APPLICATION FOR PERMIT

Portland, Maine, April 2, 1948

Location New Island Avenue, Peaks Island Within Fire Limits? no Dist. No.

To construct 1 story frame dwelling 24'x35'.

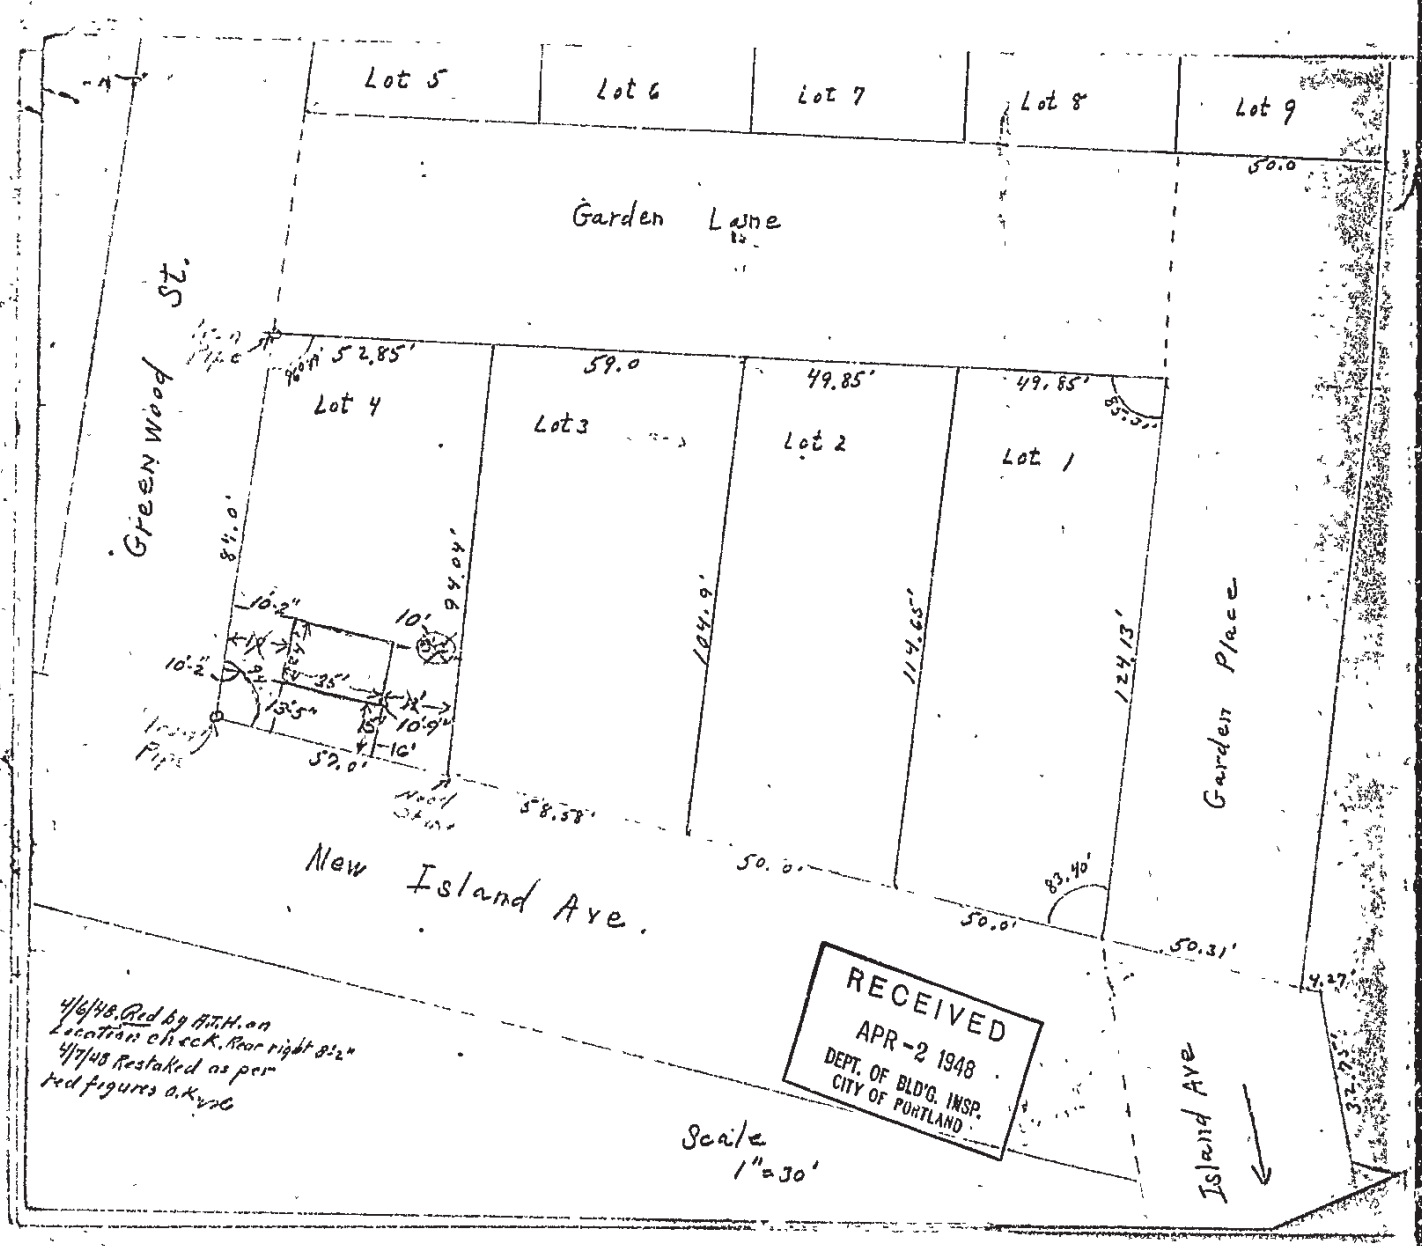
Lot 5
Lot 6
Lot 7
Lot 8
Lot 9
50.0
Garden Lane
Green Wood St.
59.0
49.85'
49.85'
Lot 4
Lot 3
Lot 2
Lot 1
84.0'
94.04'
104.9'
114.65'
124.13'
Garden Place
10.2"
10'
10.2"
35"
10'9"
10'
52.0'
S 8.58'
New Island Ave.
50.0'
50.0'
83.40'
50.31'
4.27'
Island Ave
Scale 1"=30'
RECEIVED
APR -2 1948
DEPT. OF BLD'G. INSP.
CITY OF PORTLAND
4/6/48. Red by A.T.H. on location check. Rear right 8½"
4/7/48 Restaked as per red figures O.K. V.V.C.

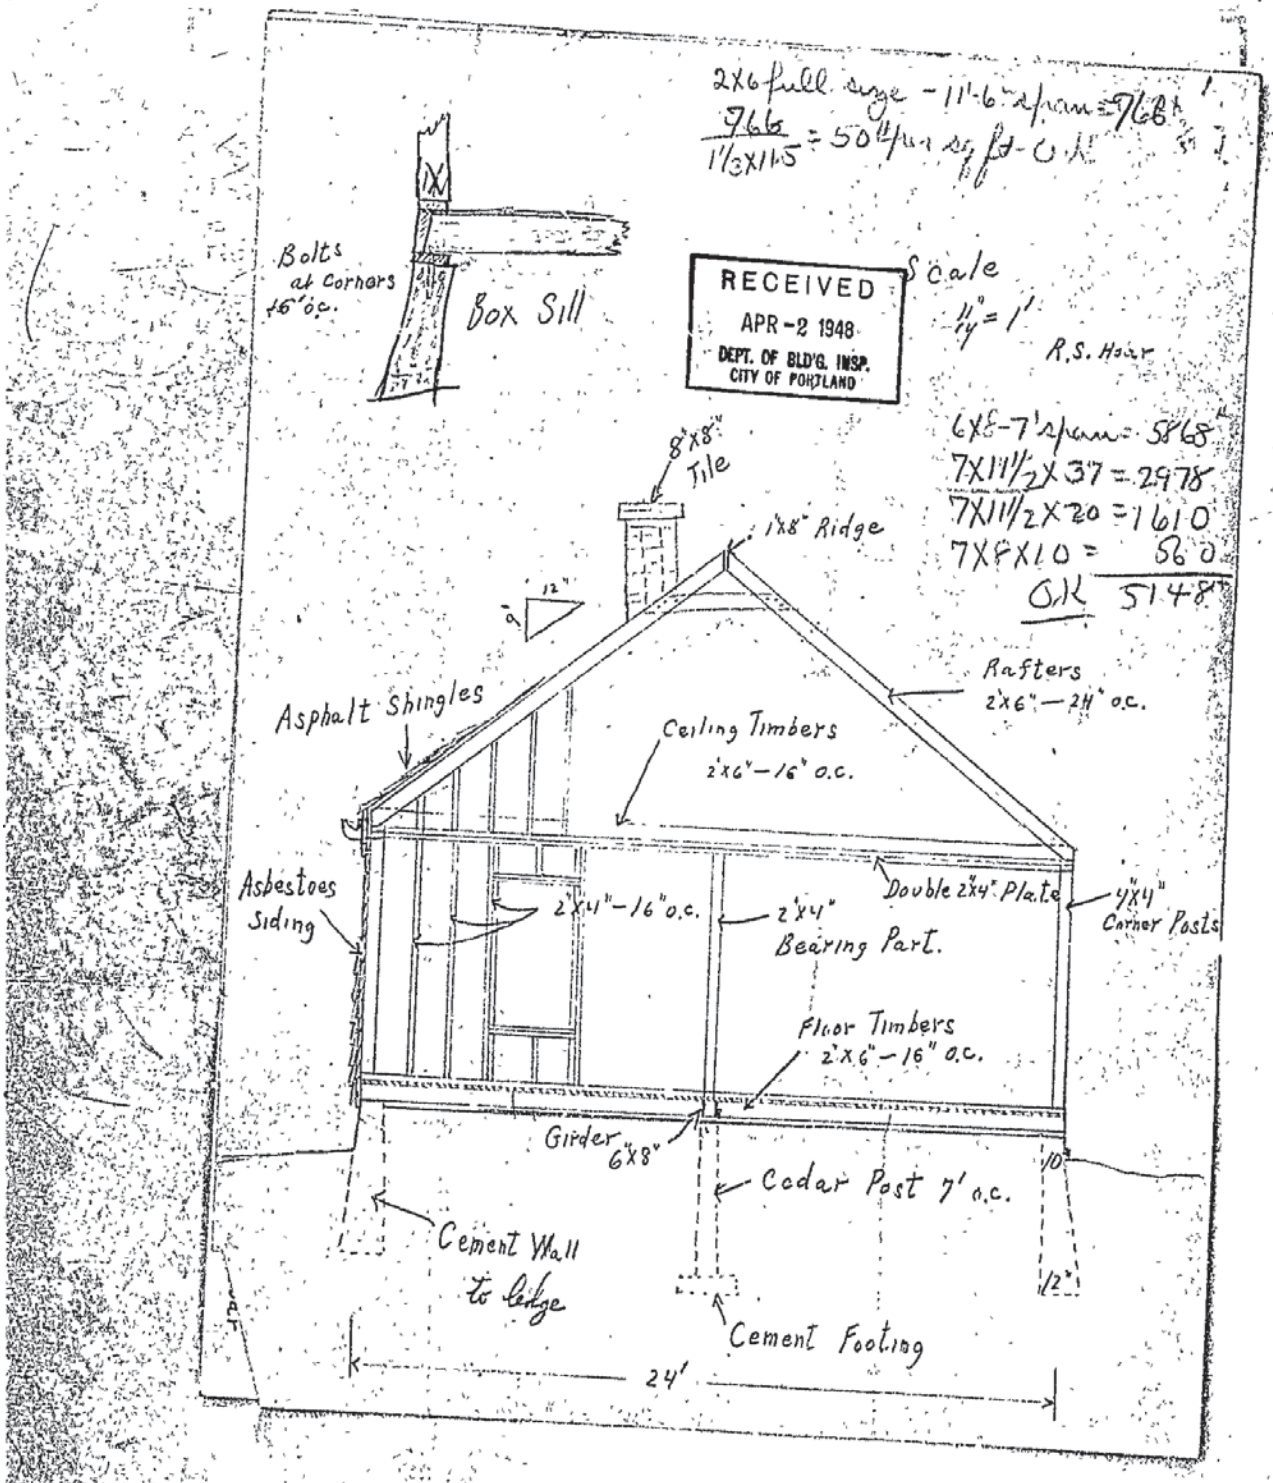
2x6 full size - 11'-6" span = 766 #
766 / 1 1/3 x 11.5 = 50 1/2 #/sq ft - O.K.
Bolts at corners 16" o.c.
Box Sill
RECEIVED
APR - 2 1948
DEPT. OF BLD'G. INSP.
CITY OF PORTLAND
Scale 1" = 1'
R.S. Hoar
6x8 - 7' span = 5868 #
7 x 11 1/2 x 37 = 2978
7 x 11 1/2 x 20 = 1610
7 x 8 x 10 = 560
O.K. 5148 #
8"x8" Tile
1"x8" Ridge
12"
Asphalt Shingles
Rafters 2"x6" - 24" o.c.
Ceiling Timbers 2"x6" - 16" o.c.
Asbestoes Siding
2"x4" - 16" o.c.
2"x4" Bearing Part.
Double 2"x4" Plate
4"x4" Corner Posts
Floor Timbers 2"x6" - 16" o.c.
Girder 6"x8"
Cedar Post 7' o.c.
Cement Wall to ledge
Cement Footing
24'
